D1003101 FRAME, PART PDM REV: X-001, DRAWING PDM REV: X-001

FRAME		SIZE	DWG. NO.	REV.
		B	D1003101	v1
SCALE: 1:8		PROJECTION:		SHEET 1 OF 1

ISO VIEW

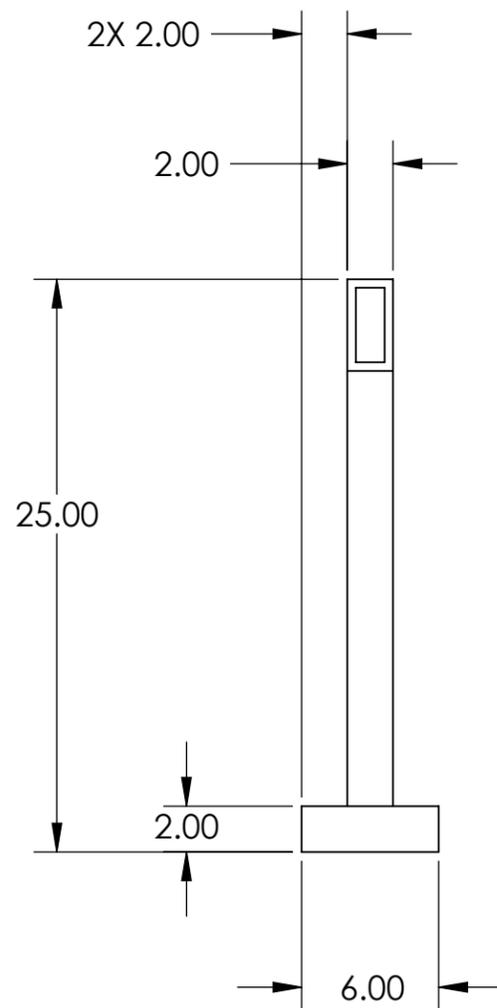
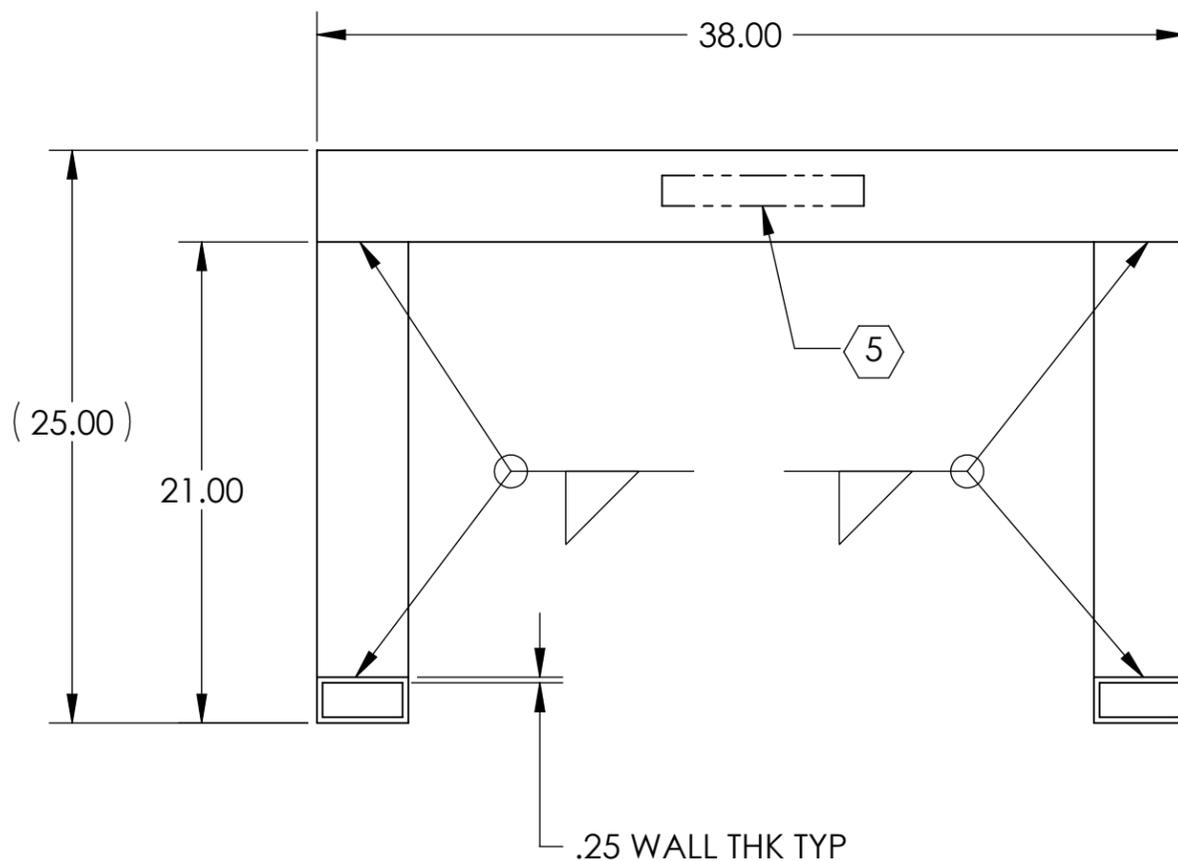
In terms of the welding, please follow: -

- * All dimensions apply after welding.
- * All welds must be complete joint penetration welds or partial penetration welds.
- * All welders should be certified to American Welding Society (AWS).
